# SERVICE BULLETIN

\* Supersedes Service Bulletin SB600N-016 dated 30 September 1998. Revision 1 adds an alternate part number for the Voice Warning LRU. Aircraft which have complied with SB600N-016 meet the intent of this revision.

## AUDIO WARNING SYSTEM MODIFICATION

**Figure 1. Component Locations**

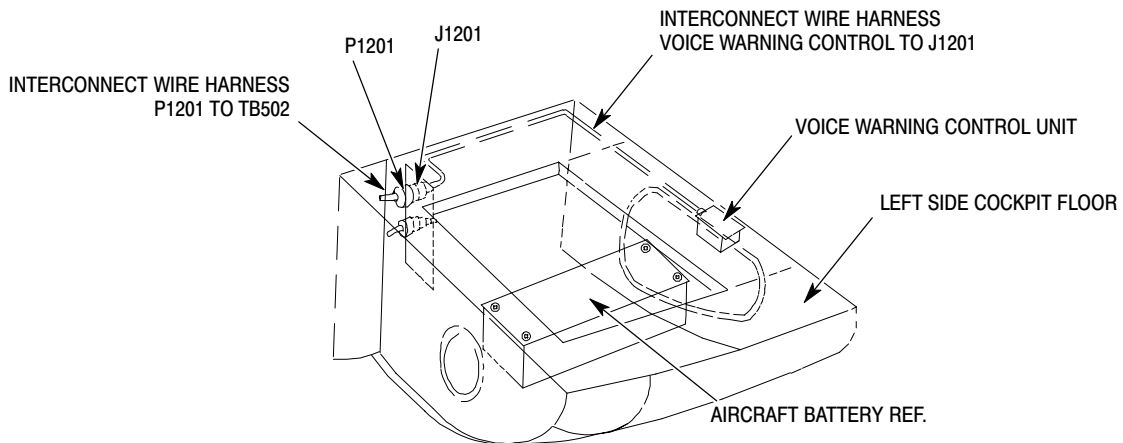
(Ref. Figure 1)

- (1). Disconnect P19 from voice warning control unit. Bag or cap P19 to prevent FOD.
- (2). Remove four (4) bolts and washers attaching existing voice warning LRU. Retain hardware for reinstallation of new voice warning LRU.
- (3). Install 600N4514-5 or 600N4515-1 voice warning LRU using four (4) bolts and washers. Torque bolts per the Handbook of Maintenance Instructions (CSP-HMI-2, Section 20-00-00).

**Figure 2. Wiring Modification**

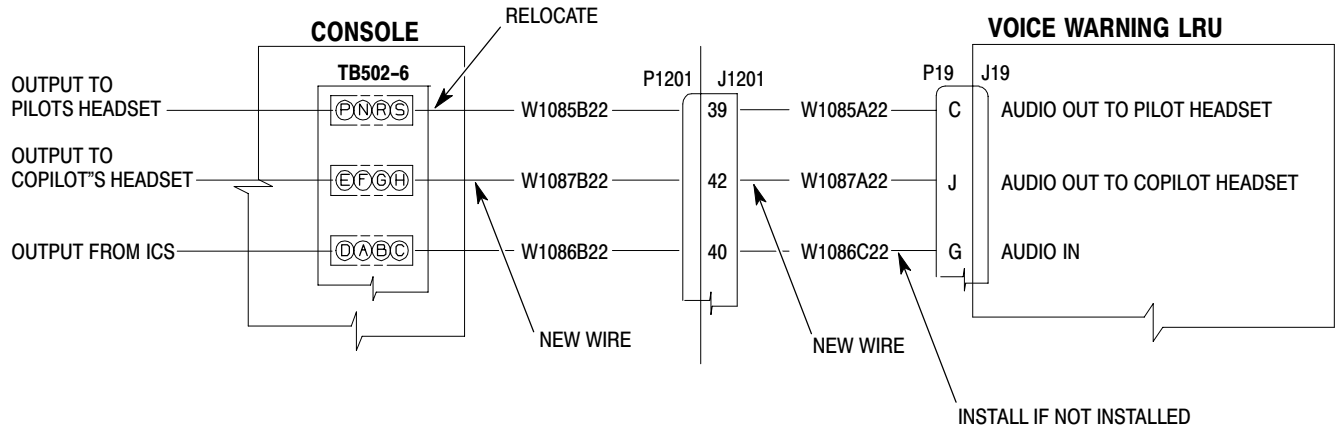
(Ref. Figure 2)

- (1). Perform Part 1.
- (2). Fabricate wires in accordance with Wire Build Table.

- (a). Visually verify if wire W1086C22 is installed from J1201-40 to P19-G. If not installed, install new wire.
- (b). Install wire W1087A22 from J1201-42 to P19-J.
- (4). Modify console wiring harness as follows:

- (a). Relocate W1085B22 from TB502-6F to TB502-6S.

- (b). Install W1087B22 from P1201 to TB502-6H.
- (5). Reconnect P19 to voice warning control unit.
- (6). Secure any opened areas.
- (7). Record compliance to this Service Bulletin in the Compliance Record section of the helicopter Log Book.
